41-43 Brigham Creek Road JV

41-43 Brigham Creek Road: Plan Change: information request regarding ecological effects

We refer to the further information request dated 18 February 2022 from Todd Elder, Policy Planner at Auckland Council regarding Council's further information request for proposed private plan at 41-43 Brigham Creek Road, Whenuapai.

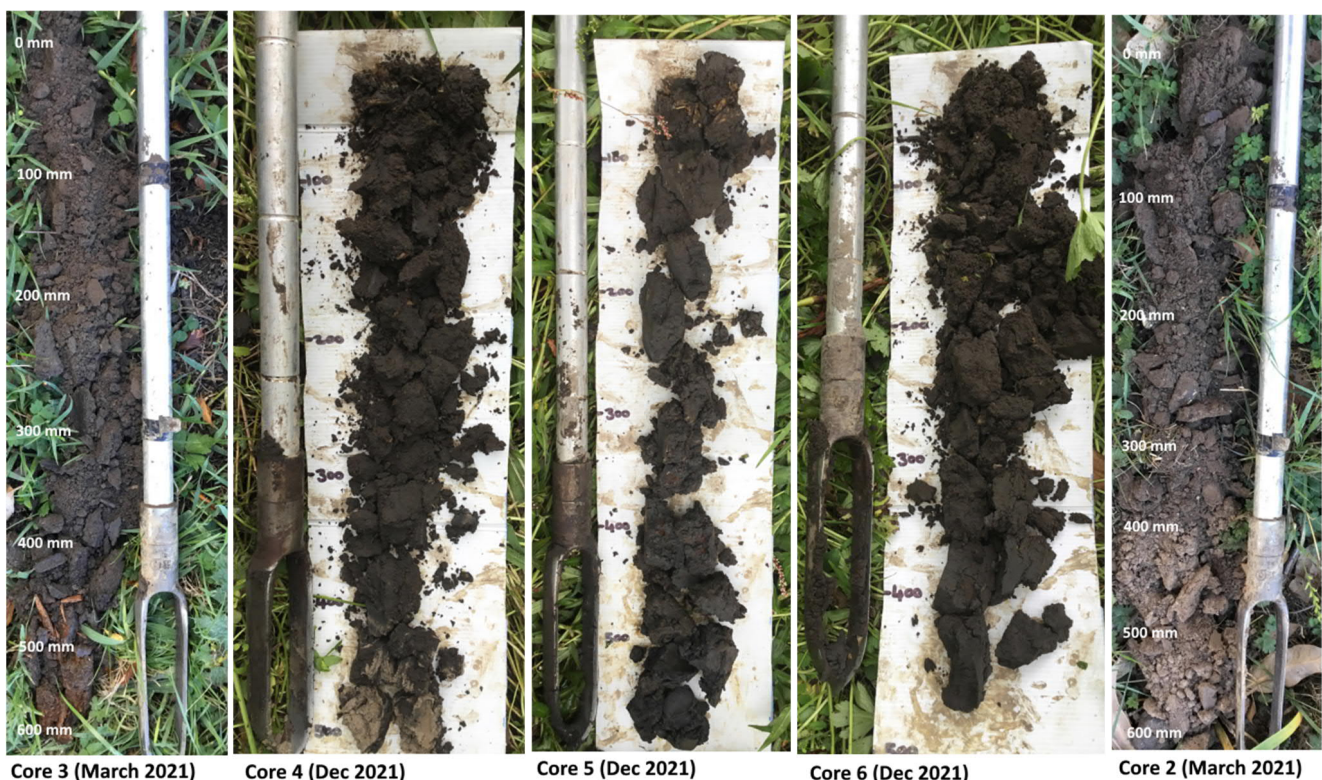
33. The Ecological Effects Assessment concludes that the potential wetland at the base of the eastern gully is a 'pond' and not a wetland. In the report this is based upon a soil core showing no evidence of hydric soils. Hydric soils can take many years to establish and therefore the absence of hydric soils alone is not sufficient evidence to determine the site is not a wetland (as is may have recently formed). During the site visit pooling water and a dominance of Ranunculus and Persicaria was observed in this area. The Ecological Effects Assessment also refers to the area as being 'seasonally wet' which would seem to indicate a wetland hydrology in excess of the thresholds outlined in the hydrology tool. If the applicant is to maintain that this area is not a wetland, further evidence including the use of the vegetation and hydrology tools would be required.

The area referred to is an area where temporary ponding of water occurs. We agree that the vegetation (as dominated by non-pasture species of wetland facultative species) is an indicator of potential wetland status. However, the soils do not match (they are not hydric).

We re-visited the site on 21 December 2021 and undertook further work on soils and vegetation. The vegetation is confirmed to comprise species that are adapted to wet environments – with a dominance of creeping buttercup and water pepper.

The flow chart within the guidance attached to the NPS-FM provides a step-wise sequence of assessment using vegetation, soil and hydrology indicators. The process requires that soils are hydric for a potential wetland site to qualify. It is not enough to have vegetation (or hydrology) as the only wetland indicators. Without qualifying soils, the site is not a wetland.

We took three more soil cores within this wet area – within the lowest point and on the edges. All soil cores were within areas dominated by wet-adapted plants (buttercup/ water pepper/ Yorkshire fog grass). These are shown below, together with the soil core taken in March 2021 within the same area, and a reference sample taken on the slope/ dry soils nearby. None contain indicators of hydric soils as defined in Fraser et al. (soil guide referred to in the NPS-FM wetland classification and delineation guidance). Soils must qualify as hydric soils for a potential wetland area to be classed as wetland – if it does not pass the soils test, it is not a wetland (see flow chart in the NPS-FM wetland delineation and classification guidance). Updates to this guidance chart in subsequent clarification documents from MfE have no legal standing (they cannot replace the NPS-FM official guidance) and in any case they also require that soils AND hydrology tests be both met together for a site to be classified as a wetland.

The current state of the environment at this low area of the site is that it is not a natural inland wetland under the NPS-FM and it is not a wetland as defined in the RMA.

(above). Soil cores taken within the wet basin on the site, and a core taken outside of the basin on the nearby slope/ spur (Core 2). Core 3 is taken after summer and shows dry soils. Cores 4 – 6 are taken just after the wet season and show moist profiles. None of the cores show redox mottling in the upper 300 mm or dark or light low chroma colours within the top 400 mm that are at variance with the reference core. The cores indicate that the basin comprises accumulated fine sediments over underlying basement clays.

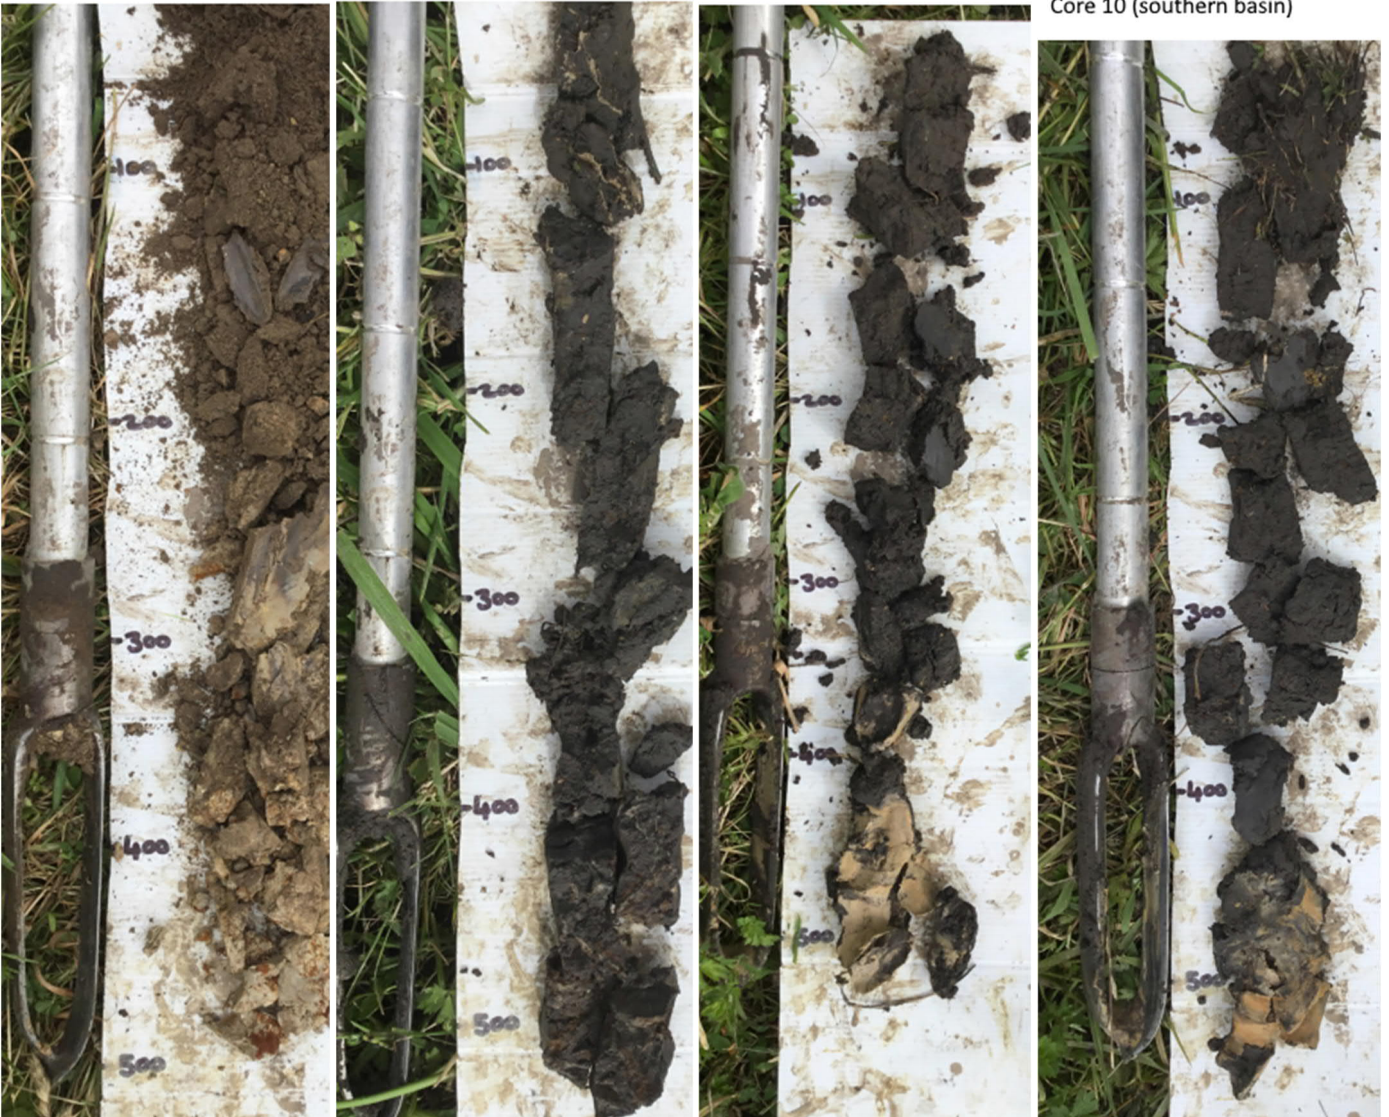
34. The Ecological Effects Assessment notes a potential natural wetland to the south of the subject site. From the site visit there would also appear to be an equally similar area approximately 30 metres to the west of the identified potential wetland.

Information request: Please comment and update assessment as necessary.

We refer to these sites as the southern wet area and the western wet area (see below).

Southern wet area:

- Vegetation dominated by Yorkshire fog (40 %), lotus (10 %) and sweet vernal (5 %), also with creeping buttercup (35 %), soft rush (10 %) and sorrel (2 %).
- Most of the stippling on the aerial photo (indicative of soft rush areas) above has either been removed by pasture maintenance since this aerial photo was taken, or is along the margins of the adjoining overland flow path; the potential wetland area is at the head of the gully and in this aerial is beneath the shading caused by the adjacent shelterbelt line.

- Soils are fine silts with no mottling and no dark or light low chroma colours in the top 400 mm (see below).
- Overall, while the area is wetter than the surrounding basin sides and spurs, the soils are not hydric, and the vegetation is dominated by pasture grass species (Yorkshire fog, lotus and sweet vernal; which are part of paddock maintenance (pasture improvement) including weed control, fertiliser application and re-seeding) – meaning that the site does not qualify as a natural inland wetland under the NPS-FM nor as a wetland under the RMA.

Western wet area:

- Vegetation dominated by Yorkshire fog (55 %), lotus (5 %) and sweet vernal (5 %), with also creeping buttercup (10 %), soft rush (5 %), paspalum (10 %), sorrel (3 %) and bare ground (7 %).
- Soils are fine, moist, silts with light red mottling in the top 300 mm and a light low chroma colour change at 350 mm (see below). This qualifies this soil as a hydric (wetland) soil.
- Overall, while the area is wetter than the surrounding basin sides and spurs and the soils are hydric, the vegetation is dominated by pasture grass species (Yorkshire fog, lotus and sweet vernal; which are part of paddock maintenance (pasture improvement) including weed control, fertiliser application and re-seeding) – meaning that the site does not qualify as a natural inland wetland under the NPS-FM.
- The site does qualify as a wetland under the RMA.

- The closest point of the wetland to the proposed development at 41-43 Brigham Creek Road is 65 m.
